# Written Representation on Behalf of the Neighbours and Users of Queen Elizabeth Park

**Nick Jarman**

Interested Party reference no: **20022545**

The image below illustrates the errors in the positions of tree groups in Esso's Schedule of Notable Trees<sup>39</sup>.

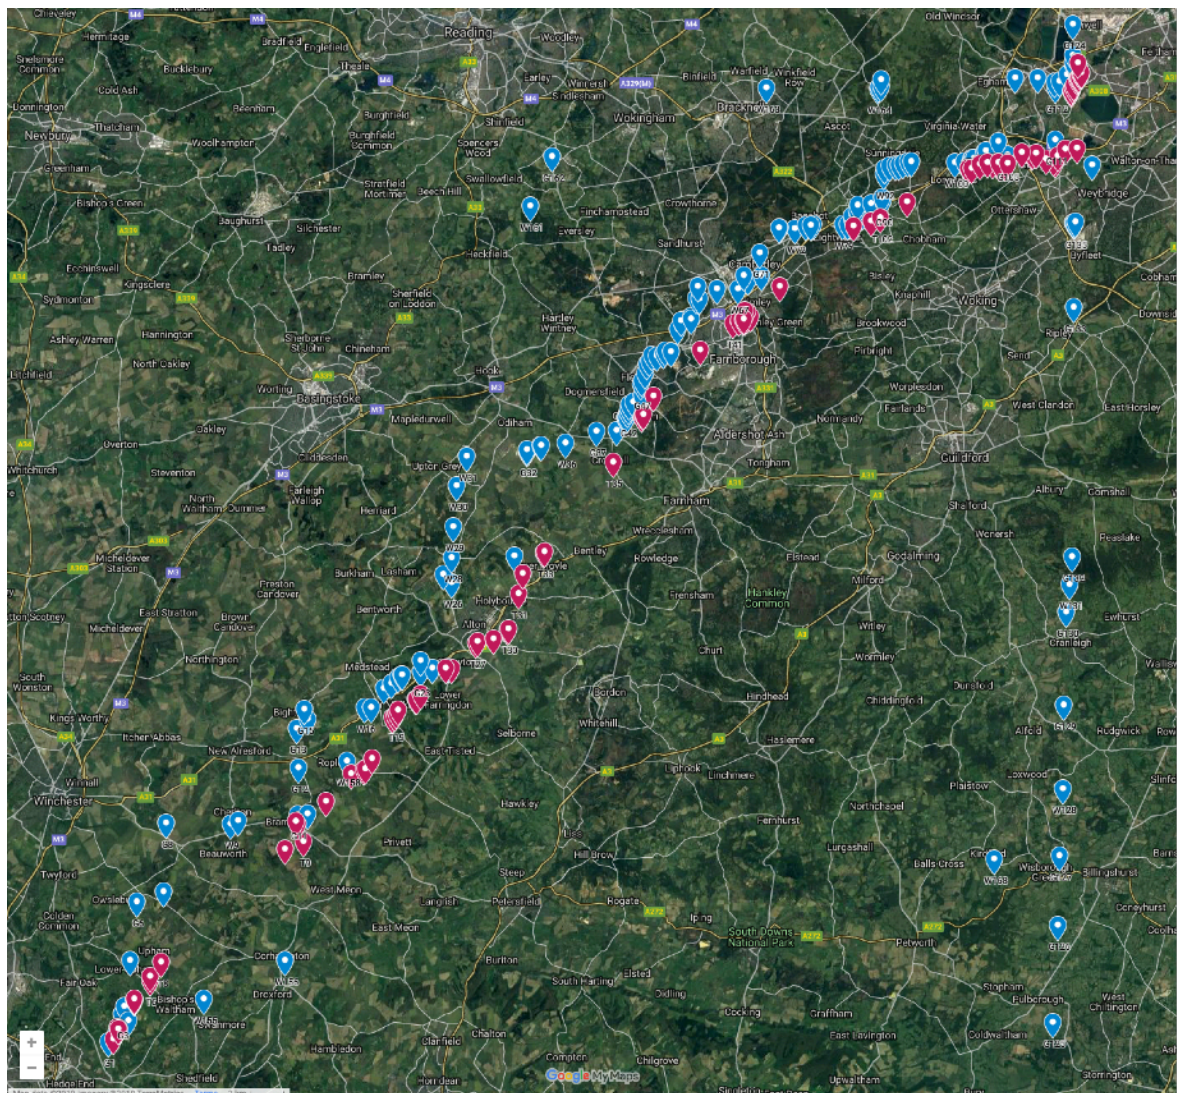
Red markers show individual trees listed in Table 1.2 of the schedule and we believe that these are accurate. The trial of red markers roughly follows the proposed route of the pipeline.

Blue markers show the tree groups listed in Table 1.3 of the schedule, most of which are inaccurate. Many are offset to the north whilst some inexplicably form a north-south line through Surrey and Sussex.

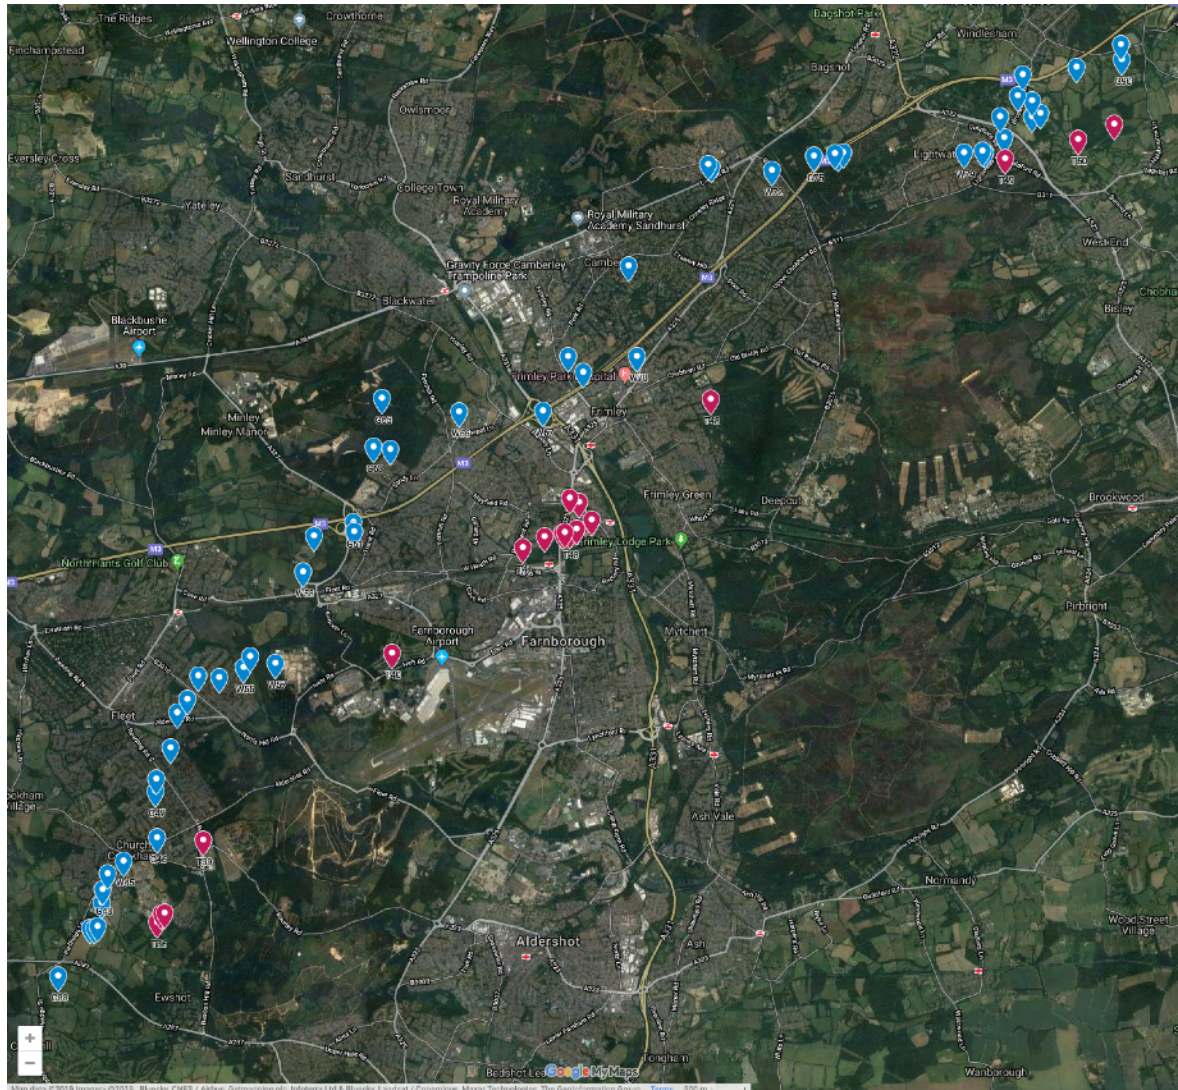
This enlargement shows the Farnborough area and illustrates more clearly how far away from the proposed route the co-ordinates of the tree groups are. The red markers are roughly aligned with the proposed route of the pipeline.
